Your ref: Docket No. 52-006
Our ref: DCP/NRC1599

SUBJECT: Transmittal of Westinghouse Responses to Open Items Identified in the AP1000 Draft Safety Evaluation Report

Westinghouse Non-Proprietary Response to AP1000 Draft Safety Evaluation Report (DSER) Open Items

AP1000 DESIGN CERTIFICATION REVIEW

Figure 3.7.2.3-1-1: ASB Stick portion of NI combined model

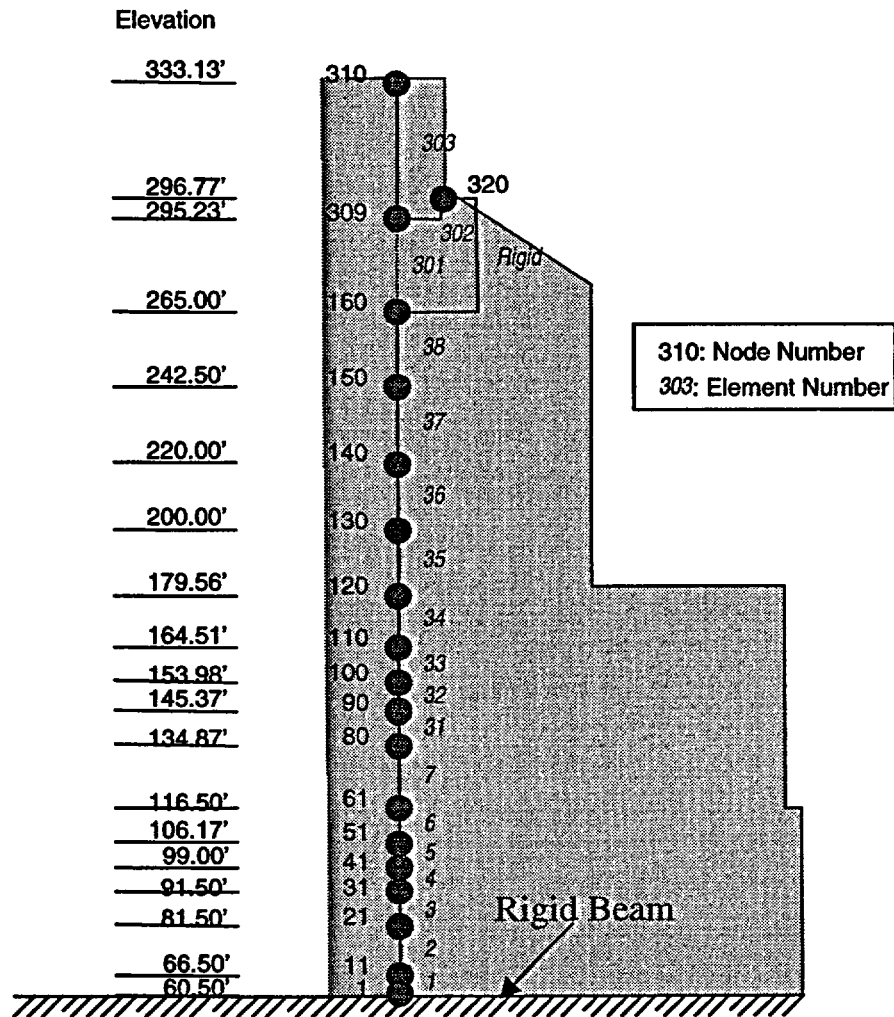
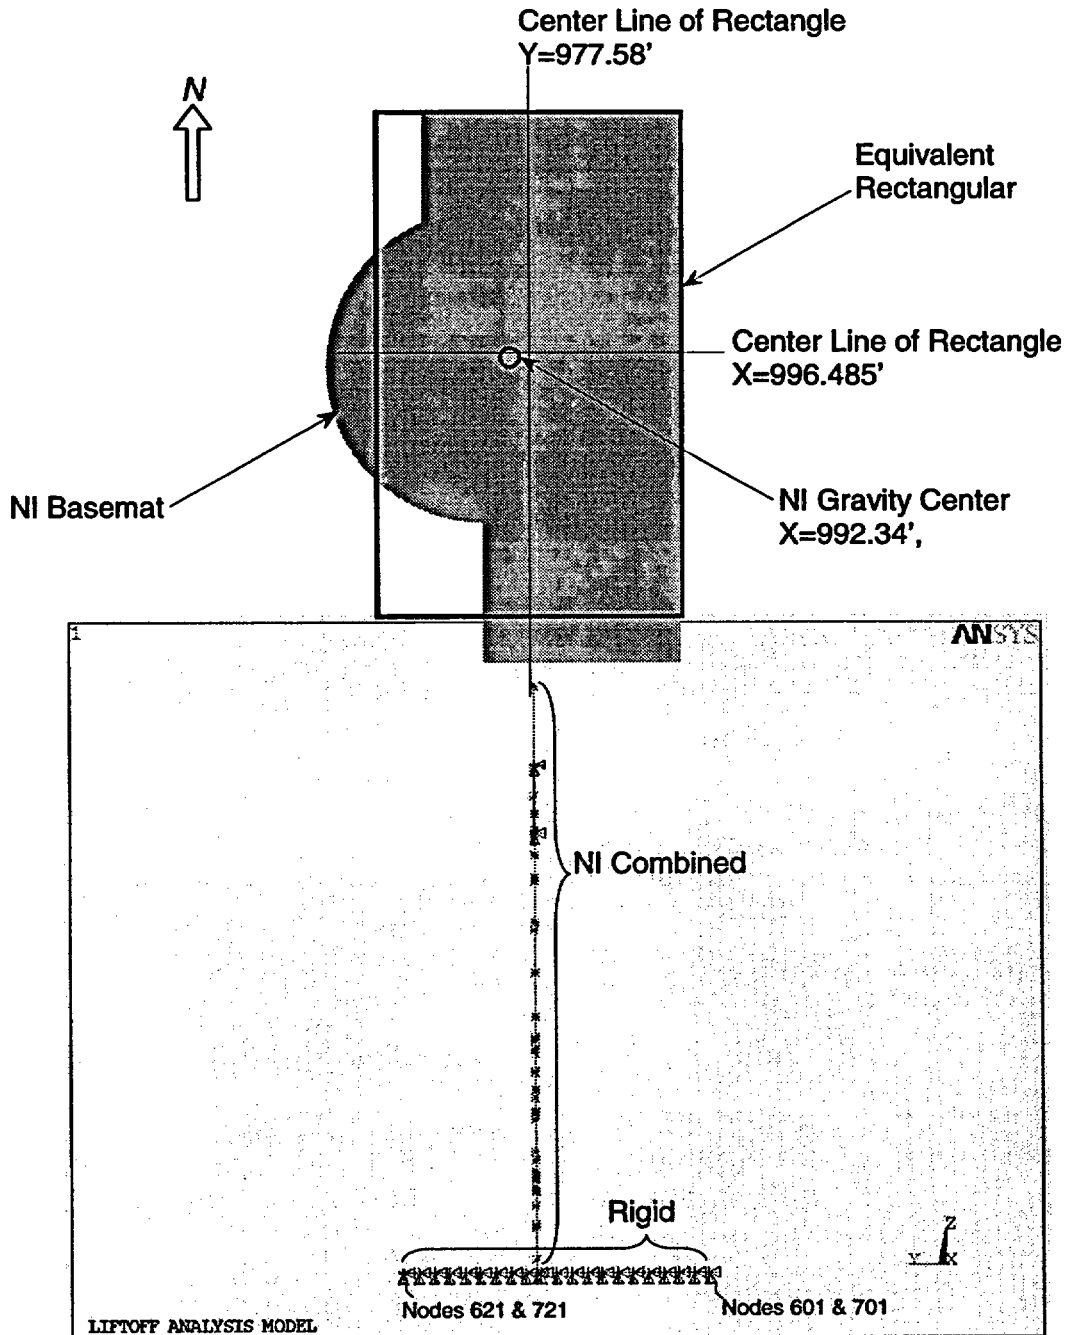
In resolving this issue, the staff, during the meeting conducted on April 2, 2003, explained its concern and expectation to the applicant regarding the significance of uplift due to seismic excitation of the NI and the effect of reduction of stiffness of shear walls. The discussion reached the following conclusions:

- The applicant will use East-West lumped-mass stick model of the NI structures supported on a rigid plate with nonlinear springs that transmit reactions in horizontal and vertical directions to simulate the foundation contact area, and perform a seismic time history analysis (the nonlinear springs will be in action only when the rigid plate is in contact with the subgrade). The results of this seismic time history analysis will be compared against the peak accelerations and the floor response spectra at the lumped mass node points obtained from the current three dimensional model analysis without the uplift consideration. If the comparison shows differences, the applicant should evaluate the significance of these differences and their effects on the current seismic design.

The effect of liftoff was evaluated using an East-West lumped-mass stick model of the nuclear island structures supported on a rigid basemat with nonlinear springs. This model is shown in Figure 3.7.2.3-1-1 and Figure 3.7.2.3-1-2. The liftoff analysis model consists of the following two submodels or element types:

The size of the equivalent rectangular basemat having the same overturning inertia as the nuclear island basemat is 140.0' × 234.5'. The basemat is modeled as a rigid beam, using 20 elements, each 7 feet apart. Hard rock with a shear wave velocity of 8000 feet per second is modeled as horizontal and vertical spring elements with viscous damping at each node of the rigid beam. As shown in Figure 3.7.2.3-1-2, the NI combined stick is attached to the rigid

basemat at the NI gravity center, which is about 9 feet from the center of the rigid basemat. In north-south direction, the stick is fixed at the bottom (EL. 60.5').

Figure 3.7.2.3-1-3: Floor Response Spectra at 5 % Damping – Node 61 (EL. 116.50')

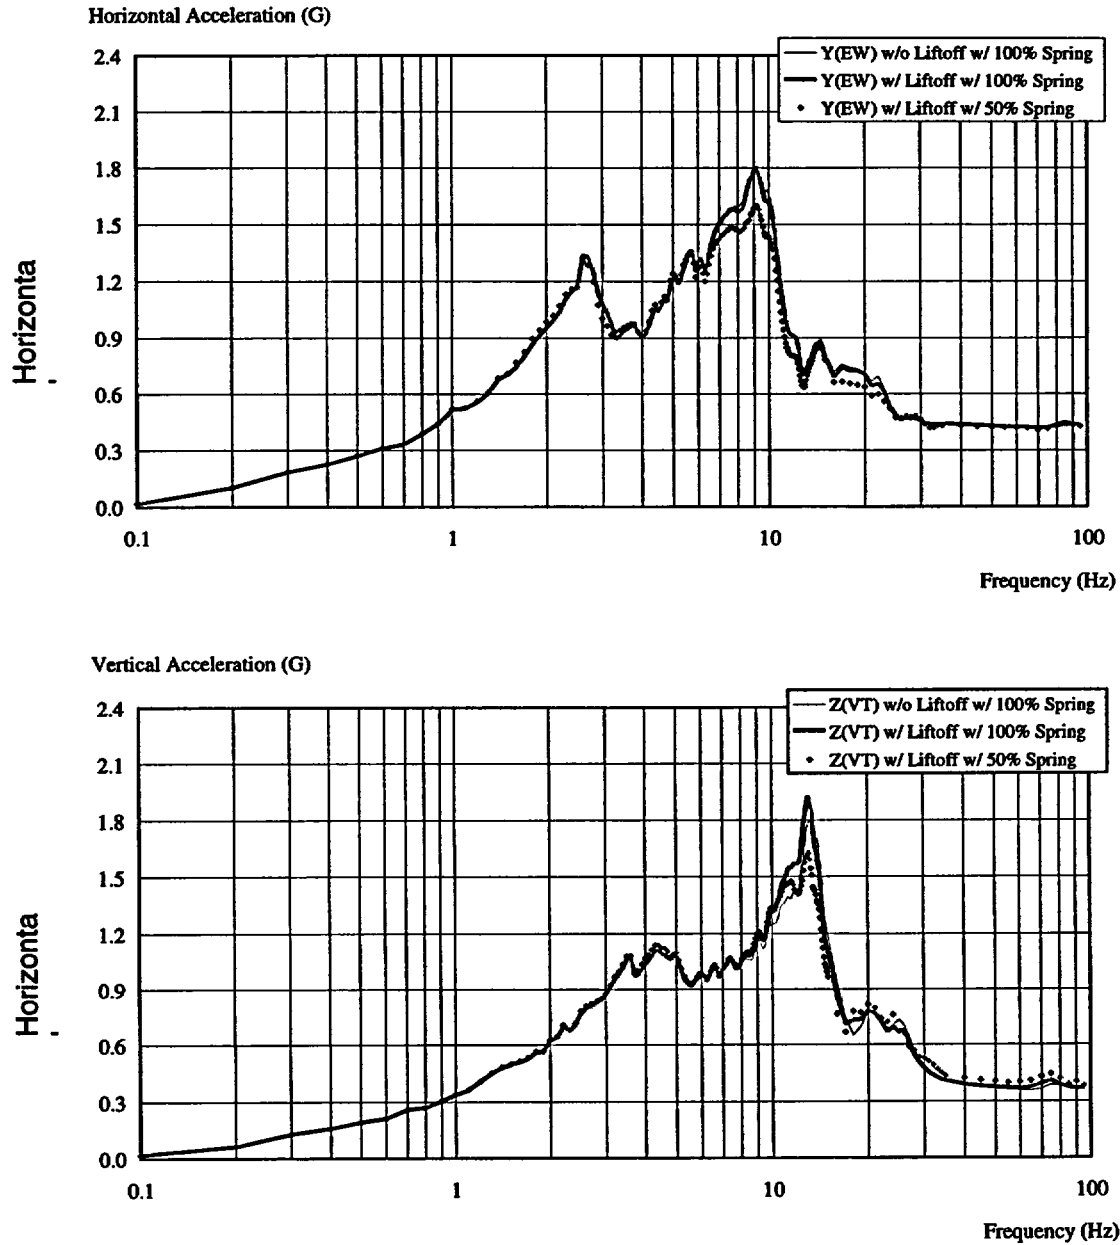
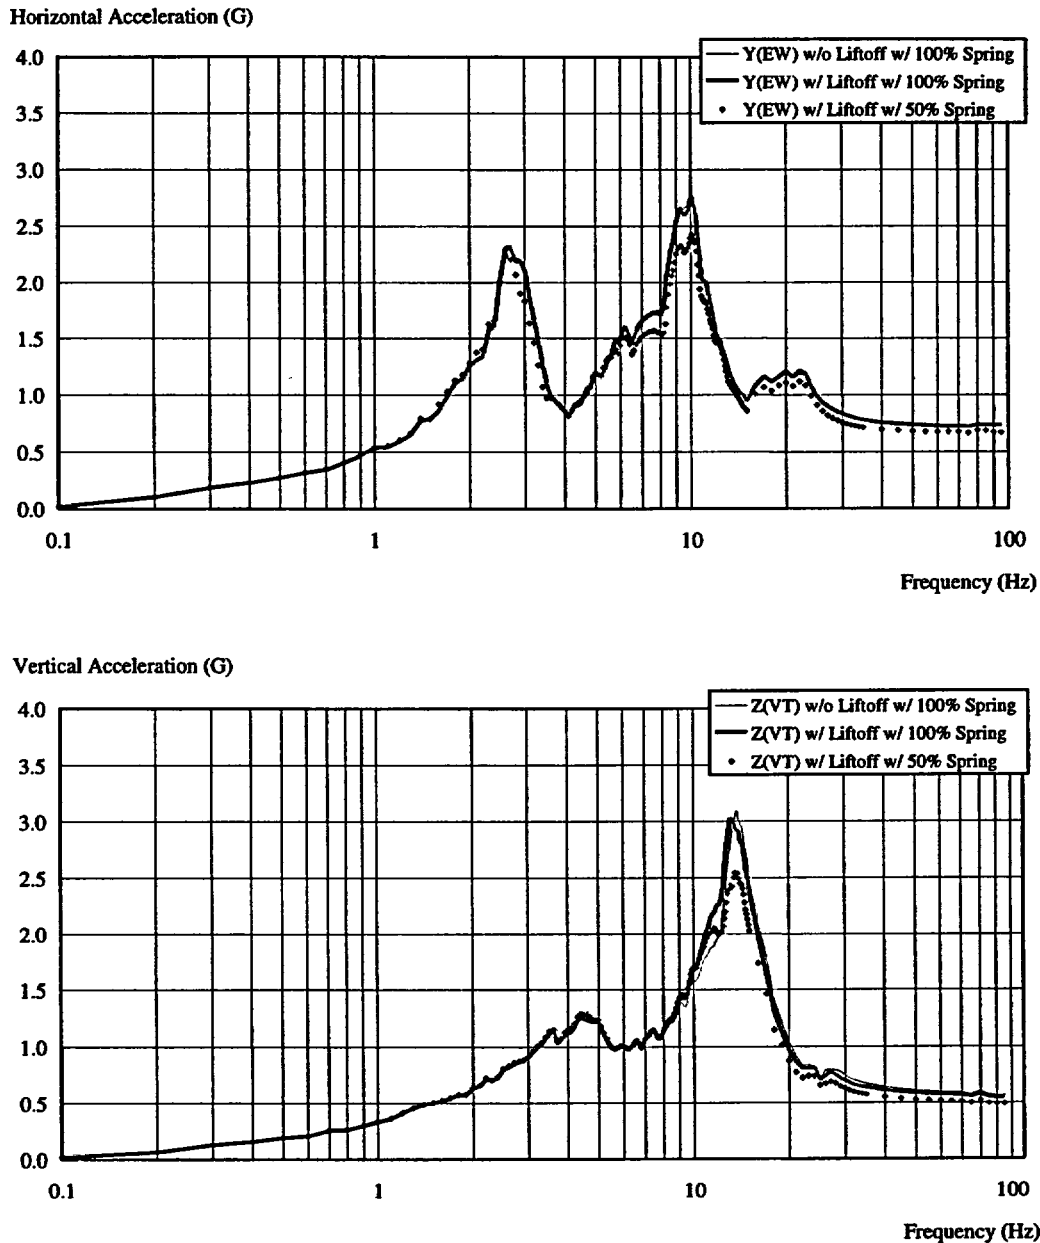
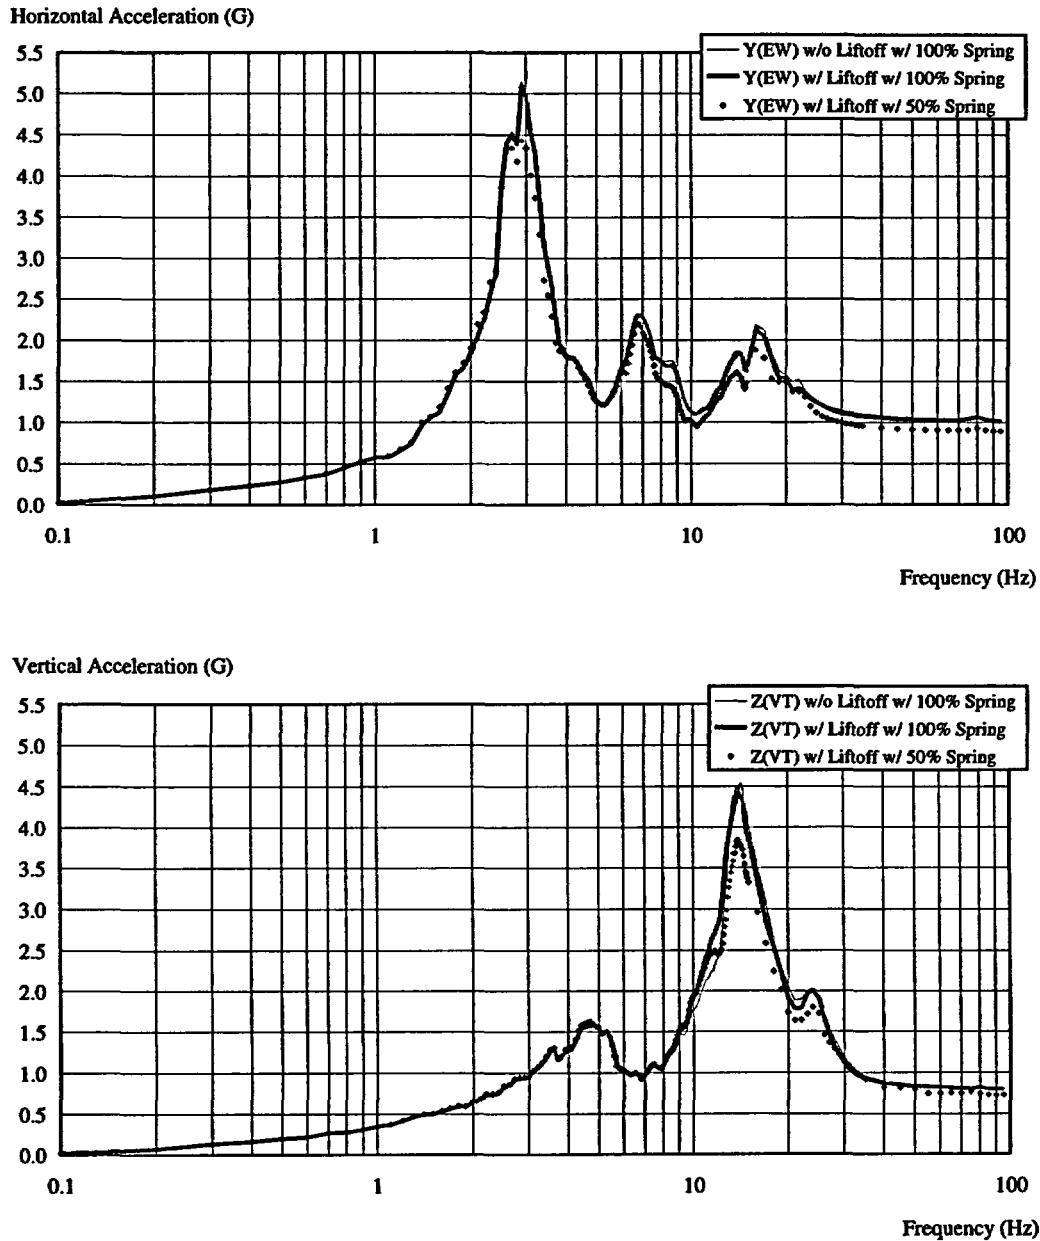
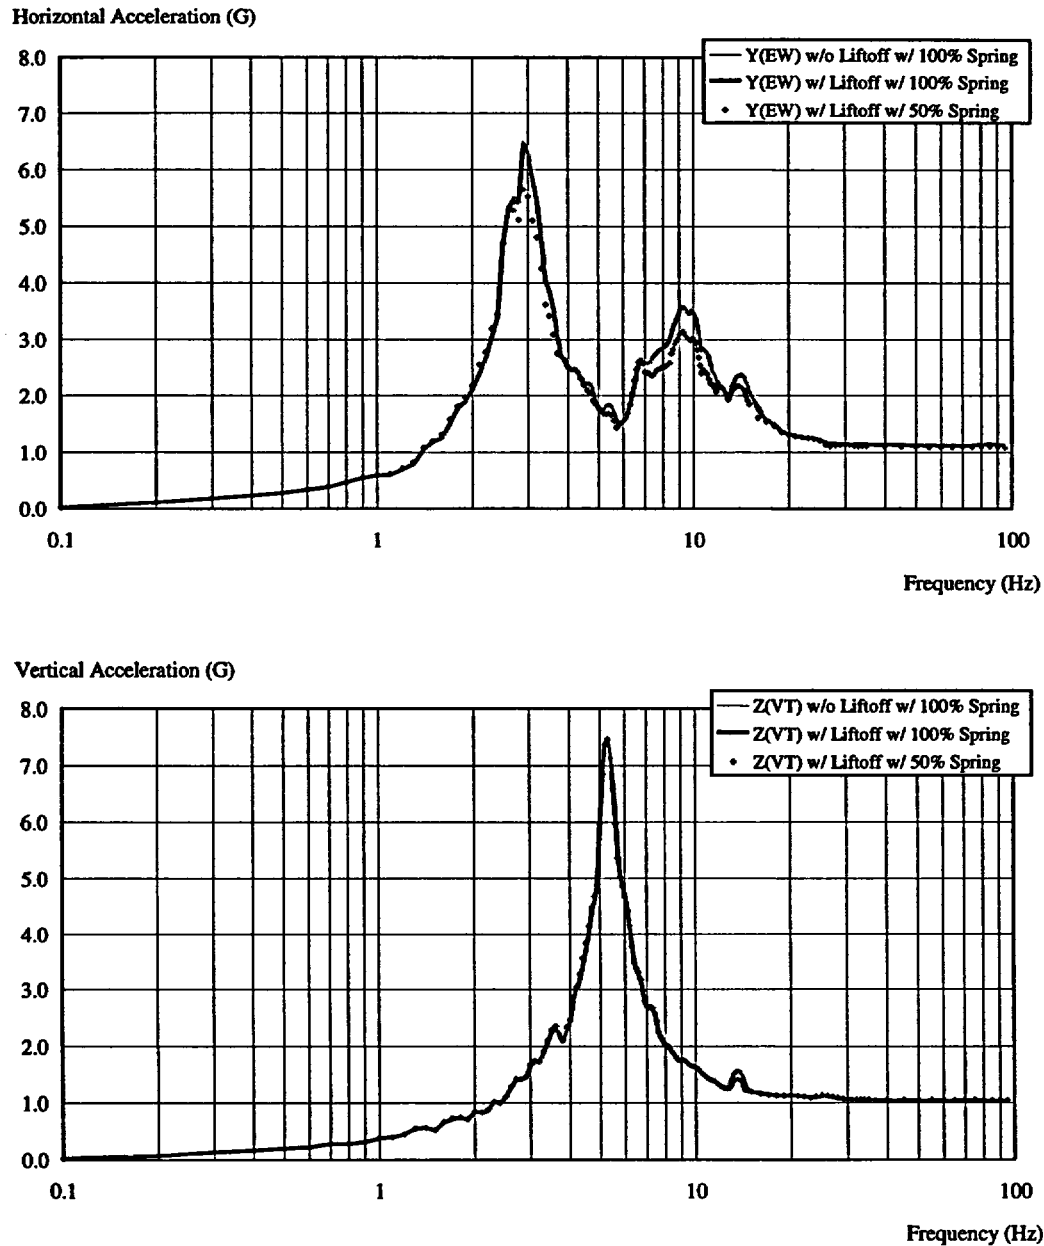
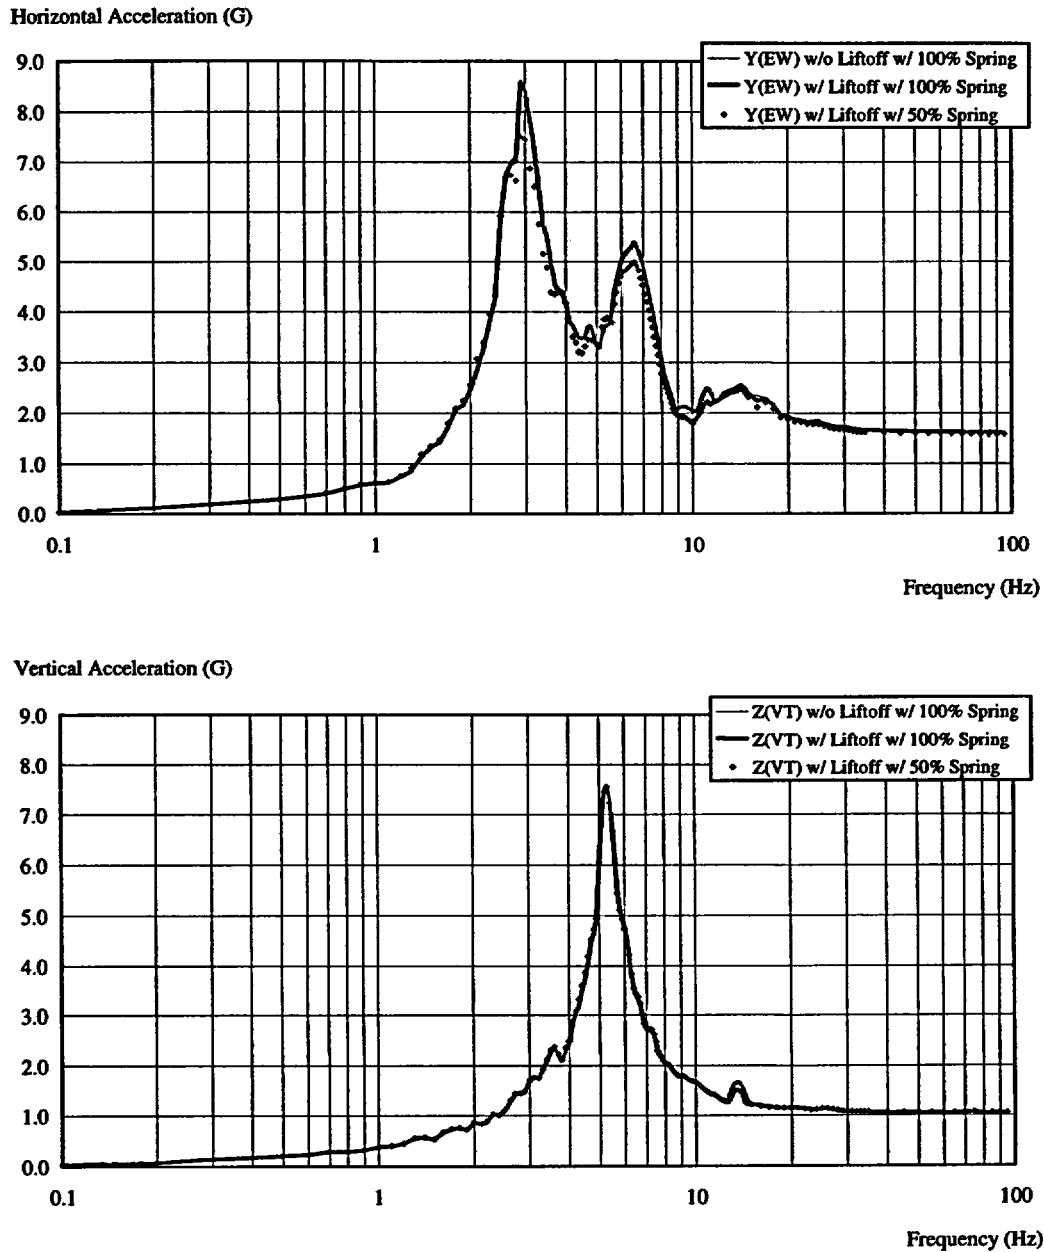
- With regard to the effect of shear wall stiffness reduction (due to shear wall cracking) on the seismic analysis results (natural frequencies, peak floor accelerations and the floor response spectra), the applicant will consider using a three dimensional (3D) lumped mass stick model with reduced member stiffnesses to conduct a time history seismic analysis. Results from this analysis will be compared against those currently used by the applicant for the design of the NI structures, systems and components. If the comparison shows differences, the applicant should evaluate the significance of these differences and their effects on the current seismic design.

When the final seismic analyses are performed for the NI structures, the applicant should incorporate the two above discussed effects in the final seismic model for calculating seismic responses. These seismic responses should also be compared against those currently used for the seismic design. If the comparison shows differences on the order of 10 percent or less, the combined effect of uplifting and shear wall cracking will be considered as insignificant. Otherwise, the seismic loads used for the design will have to be revised accordingly.

Depending on the outcome of the comparisons from the two separate analyses discussed above, one for the uplift effect and the other for stiffness reduction, the design calculations for the certified design may have to be revised. This is Open Item 3.7.2.3-1.

Figure 3.7.2.3-1-3 through Figure 3.7.2.3-1-7 show the floor response spectra in the horizontal and vertical directions at representative elevations of the auxiliary and shield building. The results show that the liftoff effect on the response spectra is insignificant, especially in the horizontal direction. In the vertical direction, especially at the lower elevation, the liftoff effects are visible in the frequency range from 10 to 25 Hz. However the liftoff effect in this range and on the ZPA (zero period acceleration) is insignificant.

Figure 3.7.2.3-1-3 through Figure 3.7.2.3-1-7 also show the case where the soil stiffness has been reduced by 50 percent. This is equivalent to the soil having a shear wave velocity of about 5600 fps. The results show that reducing the soil stiffness leads to lower building response. This is due to the larger displacement of the basemat in the reduced soil stiffness case leading to larger basemat velocities and thus damping in the reduced stiffness soil springs.
